| APPLICATION NO. | FILING DATE | FIRST NAMED INVENTOR | ATTORNEY DOCKET NO. | CONFIRMATION NO. |
|-----------------|-------------|----------------------|---------------------|------------------|
| 10/750,416 | 12/31/2003 | Paul Cooper | 1671-0289 | 4647 |

Office Action Summary

- 1) ☒ Responsive to communication(s) filed on 09 May 2006.
- 2a) ☒ This action is **FINAL**. 2b) ☐ This action is non-final.
- 3) ☐ Since this application is in condition for allowance except for formal matters, prosecution as to the merits is closed in accordance with the practice under *Ex parte Quayle*, 1935 C.D. 11, 453 O.G. 213.

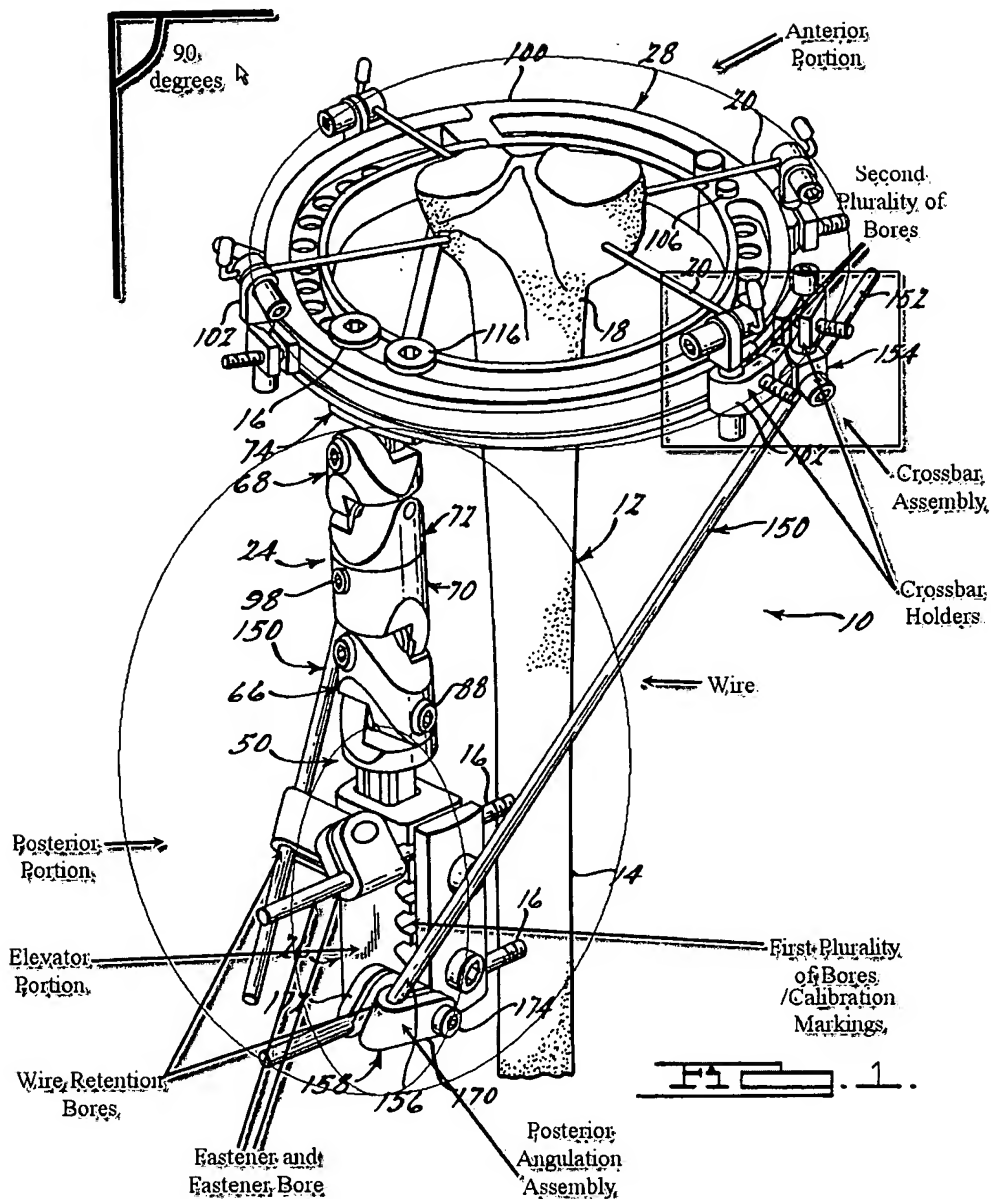
Walulik discloses an external bone/joint fixation device (see Figure below) comprising a frame component having a posterior portion and an anterior portion disposed transverse to the posterior portion, the frame component including a plurality of first fixation bores and a cross bar assembly attachable to the anterior portion of the frame component, the cross bar assembly including a cross bar component that is capable of being fixed at any one of a plurality of positions in relation to the anterior portion, the cross bar component having a plurality of second fixation bores, and a posterior angulation assembly attachable to the posterior portion of the frame component at any one of a plurality of positions in relation to the posterior portion: and a fixation wire extending from the posterior angulation assembly to the cross bar component. The cross bar component is capable of being rotated about a longitudinal axis of the cross bar component. The cross bar assembly further includes first and second cross bar holders each configured for attachment to the anterior portion of the frame component and for receipt of an end of the cross bar. Each cross bar holder is configured to clamp against an end of the cross bar component when the cross bar holder is mounted to the anterior portion of the frame component. The anterior portion extends above a first plane defined by the posterior portion. The posterior angulation component defines a wire retention bore configured to receive a fixator for receipt of a

portion of the fixation wire. The posterior angulation component further defines a fastener bore alignable with any one of the plurality of first fixation bores defined in the posterior portion of the frame component. The device further comprises a fastener extending through the fastener bore and a first of the plurality of first fixation bores defined in the posterior portion of the frame component. The device further comprising an elevator configured to extend about a bottom portion of the frame component and allowing access to a sole of the foot. The elevator is adapted to evenly distribute pressure applied thereto. The elevator is arcuate shaped. The frame component forms a continuous loop, the posterior portion defines a first part of the continuous loop, and the anterior portion defines a second part of the continuous loop. The device further comprises calibration markings disposed on the posterior portion. The frame is fabricated from at least one of a composite material, a polymer, a metal alloy and a shape memory material. The frame is fabricated from a radiolucent material (col. 8, lines 12-20).
